Project # 3020338

Arborist Report Correction Notice #1

RE: 2925 E Madison St
Correction Notice #1 Response

Response to City Corrections Notice #1

Appendix A – Trees located on current tree Survey

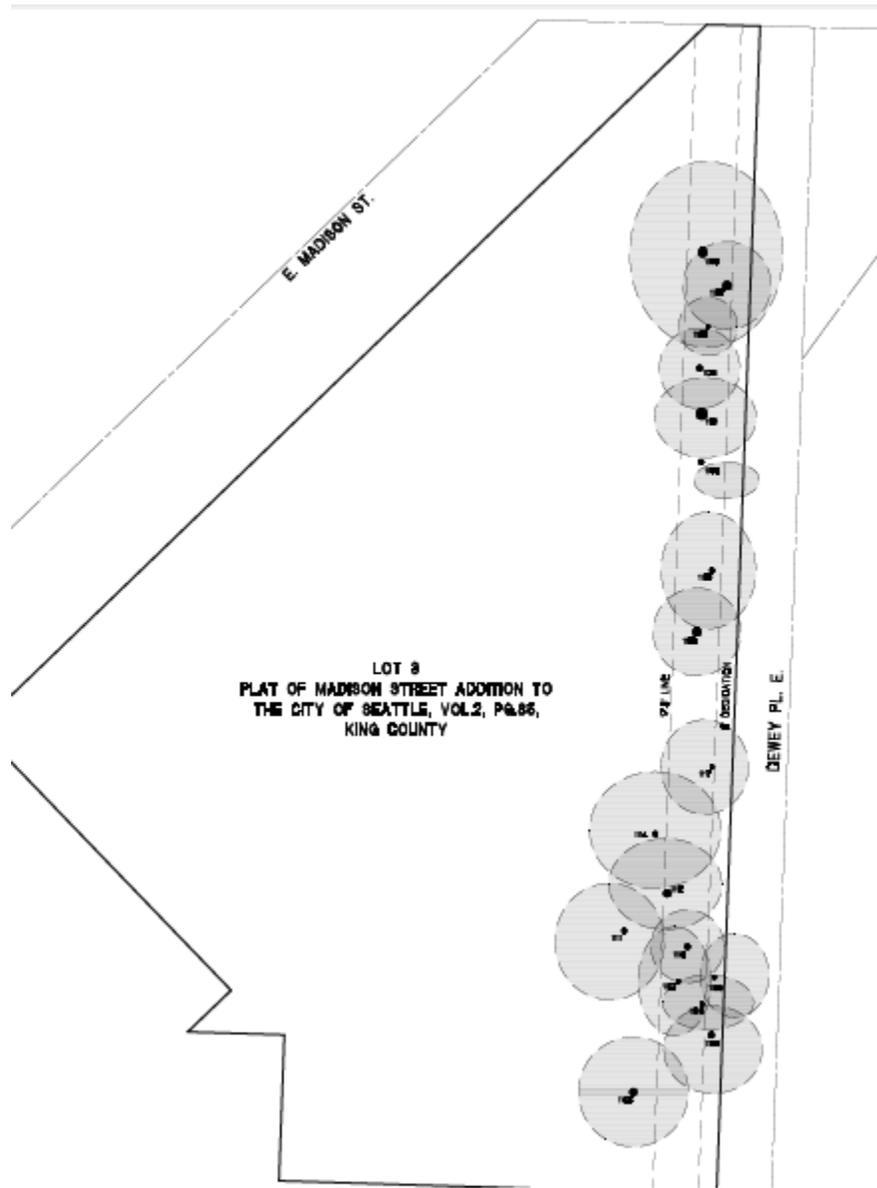
There are two clusters of trees along the north and south ends of the lot along Dewey Pl E. that seem like they could potentially constitute a “grove” of trees, as defined in SDCI Director’s Rule 16-2008. Please have the arborist confirm that he has considered whether there are any “groves,” which would be “exceptional trees,” on the site, and provide details of any analysis performed to make this determination. A graphical depiction on a site plan exhibit could be helpful to show how this analysis to identify any groves was completed.

Corrections Item 3

The arborist report indicates at least one "exceptional tree" and other trees with trunk diameters in excess of 24 inches at 4.5 feet above ground will be removed for this proposal. Removal of any such trees is subject to the tree canopy replacement requirement under SMC 25.11.090. To show that this requirement will be met, we need a landscape plan that clearly shows replacement trees and supporting calculations showing that the canopy of the replacement trees will, upon their maturity, equal or exceed the canopy of "exceptional trees" and trees 24 inches or greater that will be removed.

To determine if the presence of groves exist, I used the following methods. I measured the diameter at standard height and canopy radius in the four cardinal directions for each tree. The canopy coverage is shown on the site survey as an average of the radius to the north/south and east/west. To determine if trees are to be included as part of a grove I evaluated the canopy of each tree 12 inches in diameter and greater to see if they formed a contiguous canopy. If any tree did not have a portion of its canopy in contact or overlapping any portion of an adjacent tree, it was not counted.

Based on these findings, on the north end of the site, there are less than eight trees that are 12 inches in diameter and greater that have a contiguous canopy. This does not meet the definition of a grove. At minimum, three of the trees (1131, 1134 & 1137) will be compromised by the construction of the retaining wall west of the dedicated ROW. Trees 1131, 1134 and 1138 will all be compromised by the construction of the wall to the east. The compromised trees will present a greater probability of tree failure to the new construction to the west and Dewey Pl. E to the east.

The trees at the southern portion of the site, as it currently exists, meets the Code definition of a “grove” of ten trees with a diameter of 12 inches and greater with a continuous canopy. However, to be in compliance with city code, the ROW along Dewey Pl. E. needs to be brought up to City street standards. Trees 1105, 1106, 1109 & 1117 will be located in the ROW and as per the Director’s rule these trees will not be counted as part of the grove post-construction. Removing these trees reduces the number of trees in the stand to six trees, below what is needed for a “grove”. The loss of the canopy from these trees also separates the contiguous canopy.

All trees less than 12 inches in diameter have been removed from the Eastern Tree Exhibit. The Exhibit shows the location of and canopy dimensions of all trees 12 inches in diameter and greater. The five foot setback line depicts the location of the required dedication. The slope stabilizing retaining wall will at minimum be placed two to three feet west of this dedication. The 17.5 foot setback line shows a maximum setback line for the face of the building and illustrates the challenges in retaining trees on the slope given the building envelope, required ROW dedication, and retaining wall location.

Arborist Response 3

Canopy coverage of Exceptional trees and trees over 24" in diameter is equal to 4,717 square feet. The mature canopy of the replacement trees is equal to 10,545 square feet.

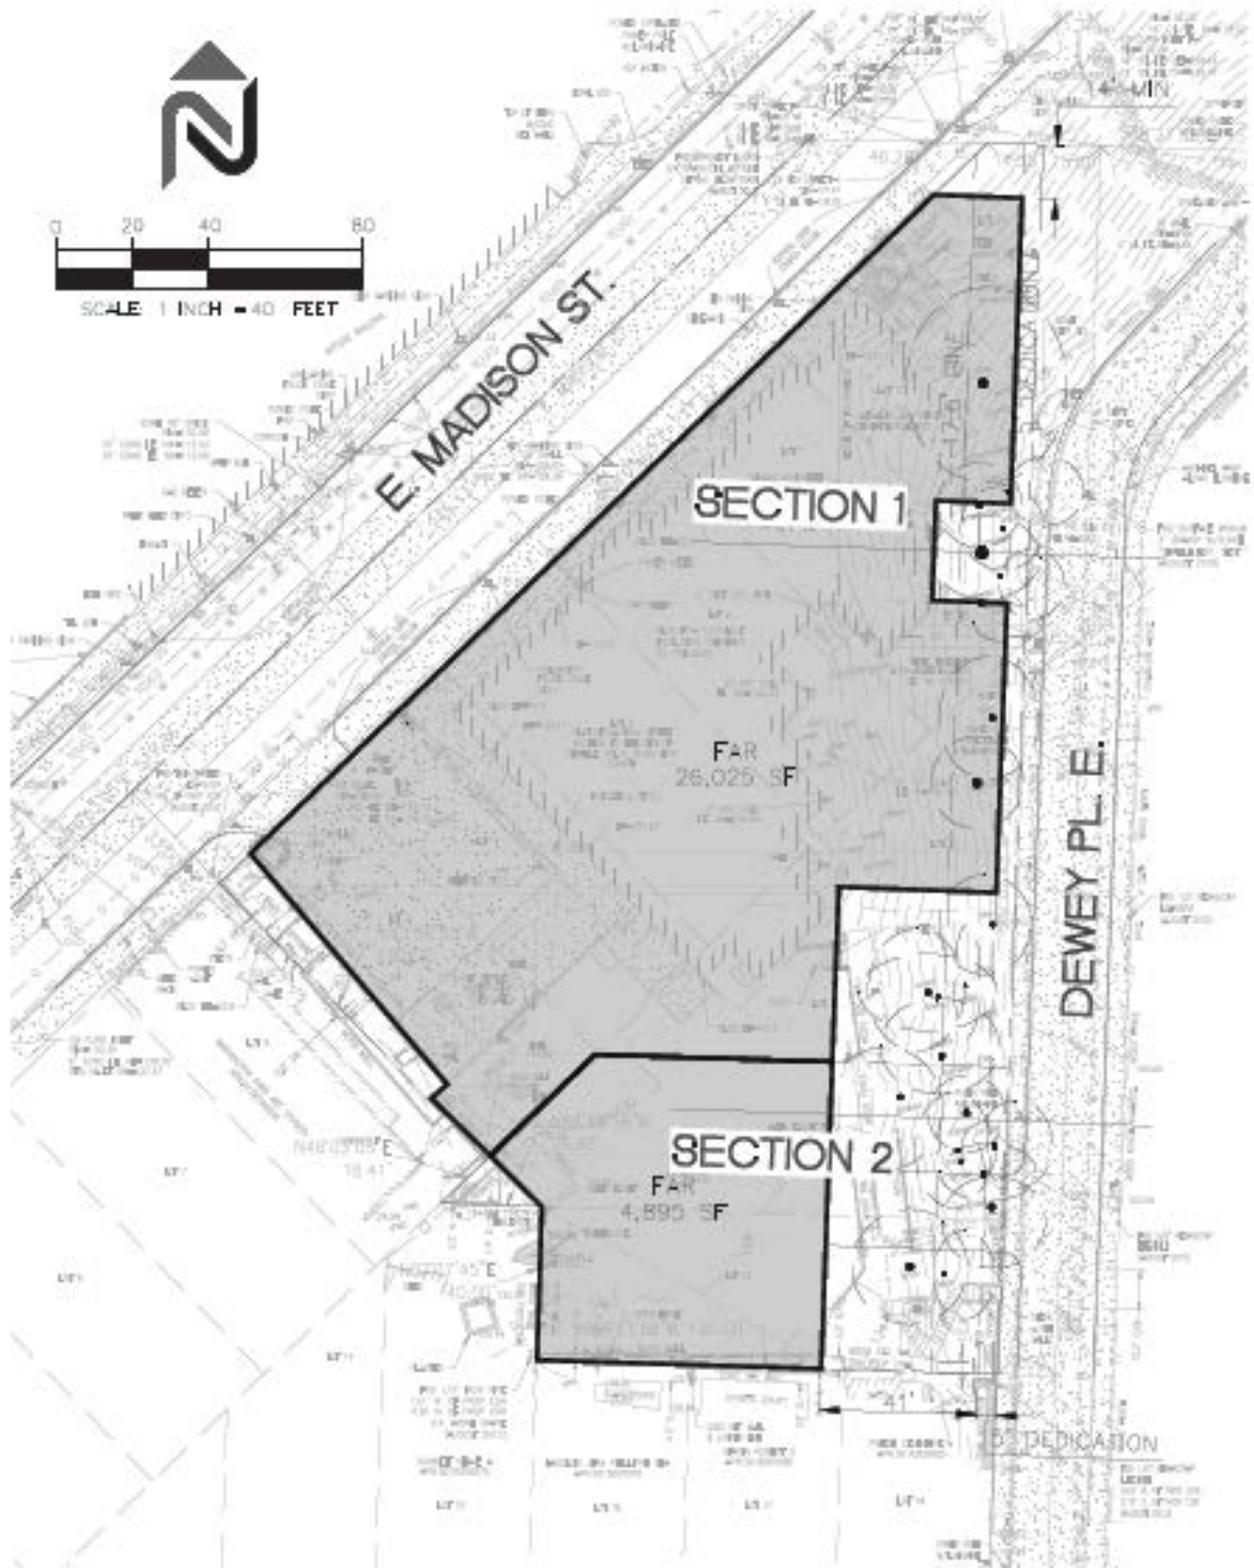
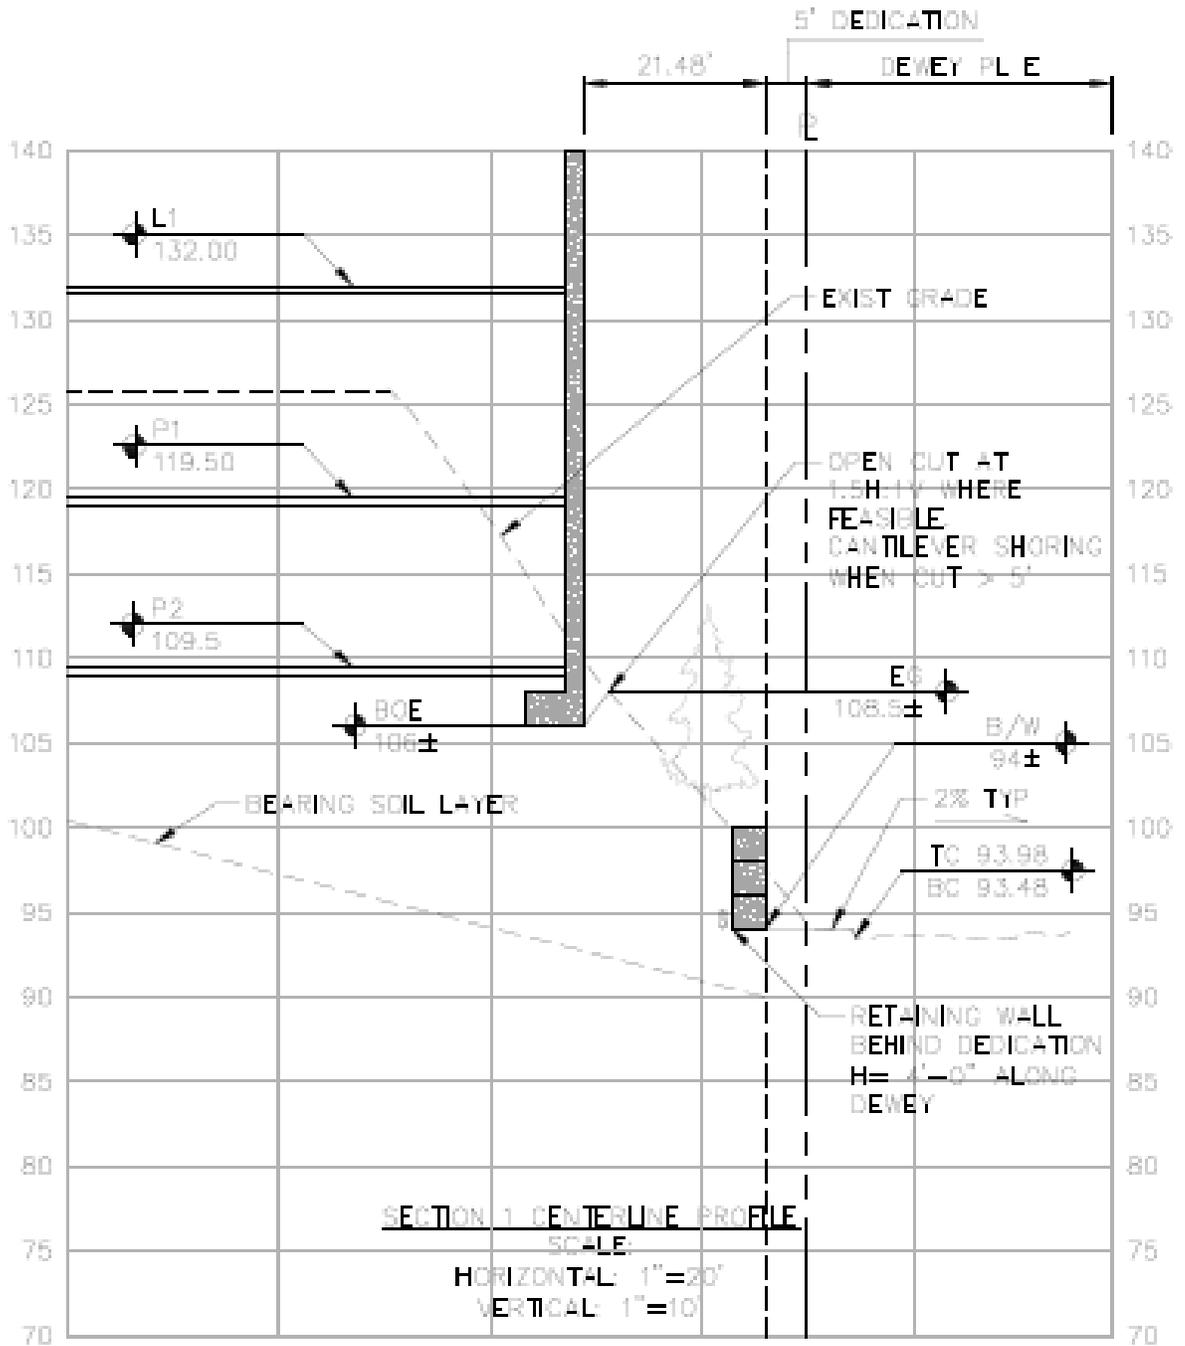
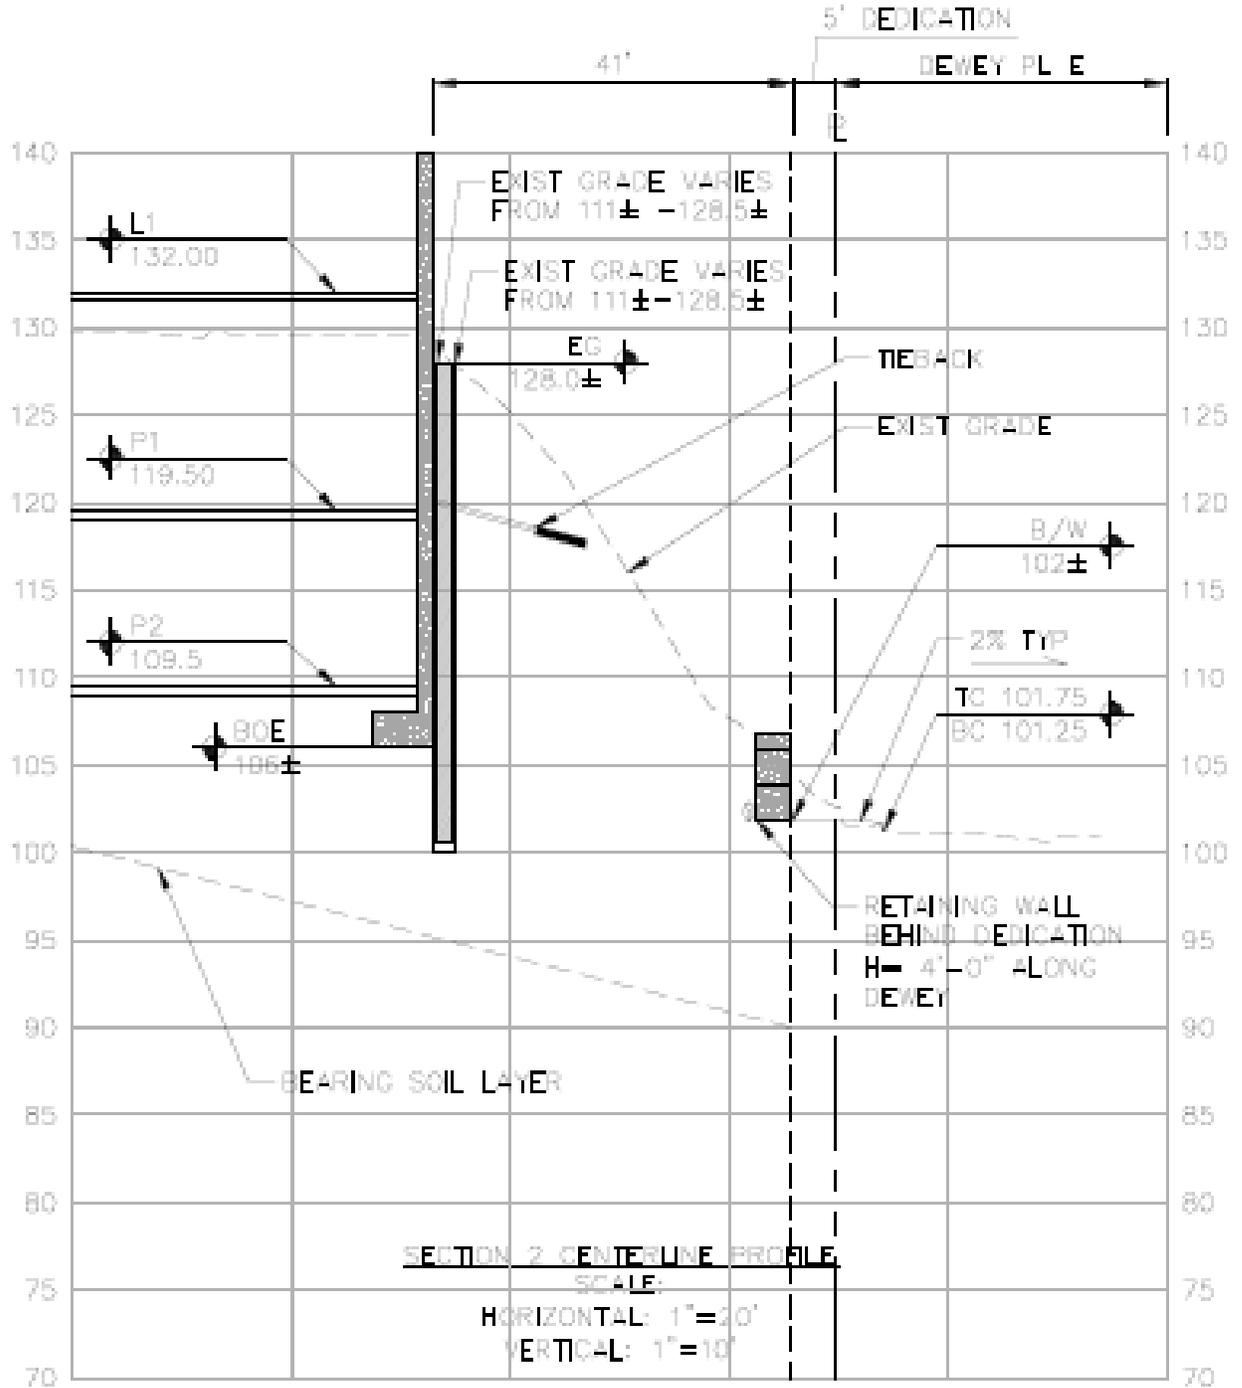
Please provide more details to demonstrate that the 13 trees noted in the arborist report (page 1) cannot be retained due to the proposed upgrade of the East Dewey PI right-of-way. What work is proposed in the right-of-way and how will the tree specifically be impacted?

Per the project arborist, the required retaining wall will impact tree 1131, located in the building notch, as the existing tree is located approximately 5 to 6 feet behind the 5'-0" dedication. See Section 1.

The required retaining wall will also impact several trees along the south of the property. See Section 2.

Temporary shoring could also be installed along the Dewey frontage in order to minimize the excavation footprint and minimize impact to the trees. Along the south end, where the building is set back 41 feet from the dedication line, the shoring system would need to support approximately 5 to 22 feet of soil. Cantilever soldier piles could be utilized for shoring heights of 15 feet or less, while tiebacks would be required for heights above 15 feet.

At the south end, a wedge of soil would be left between the proposed building and the new retaining wall located behind the dedication line. The slope of the wedge of soil would match existing conditions. See Section 2.

At the north end, the bottom of excavation (elevation 106) would be near the existing grade (approximately elevation 108). Therefore, shoring would not be required and an open cut could be utilized. See Section 1.
